Application for Hearing before the Development Review Board

TOWN OF CHESTER NOTICE OF HEARING FOR FLOOD DAMAGE PREVENTION REVIEW

Richard Rondinone III has applied for Flood Damage Prevention Review of a driveway replacement bridge across the regulatory floodplain of Kingdom Valley Brook at 1638 VT RT 11 E in the Town of Chester.

PROJECT: INF 113-22
SITE PLAN FOR ACCESS BRIDGE
PREPARED FOR ROADVED ROUNDINE
ROUTE 103 STRAM
VERMONT

DWG NO: B1
REV: 0

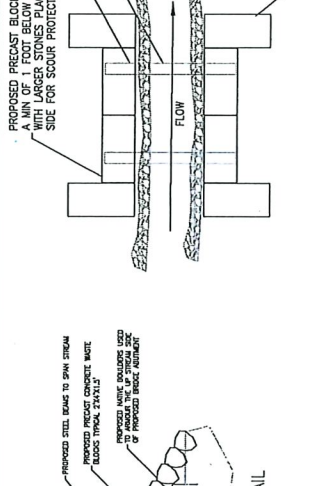
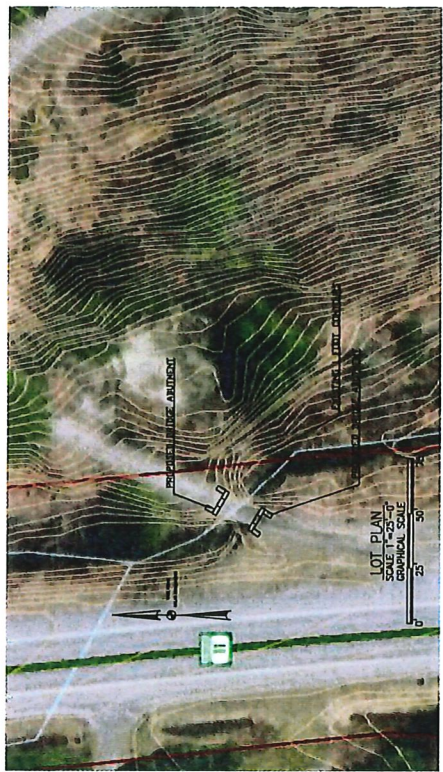
It has to be a 100 year event with 1 foot of freeboard. Anecdotally it appears that this bridge will be high enough but we still need documentation from you. This is a decision that has to go before the town Development Review Board, which means a public hearing, and we will need a so-called 4424 review by the state Regional Floodplain Manager prior to the hearing. All to say that a BFE sooner than later would benefit Richard Rondinone because he would like to build this summer.

The bridge you designed for Richard Rondinone at 1638 VT RT 11 E in Chester (Project: JN# 113-22) is going to have to undergo flood plain review. The bottom chord of the bridge deck will have to be 1 foot above Base Flood Elevation. Have you calculated BFE for this location?

I have calculated the BFE for the project. I have attached the Stream Stats data sheet that was used to obtain the CFS (Cubic Feet per Second) based upon this along with the cross section of the stream at Richards location I have the following information.

Center of Stream Elevation = 715.1'
BFE for 100 year flood = 722.19'

Based upon these numbers I believe it will be about 1 foot higher in elevation than the existing bridge.
Please let me know if you have any questions or need additional information

I did not calculate a BFE for this project since it was a replacement of an existing bridge (which made it through Irene) I would be glad to calculate a BFE but I need to know for which storm event. Typically Towns and private bridges are sized to a 25 year or possibly 50 year event when public access bridges are sized to the 100 year event. Which event would you like the BFE for?
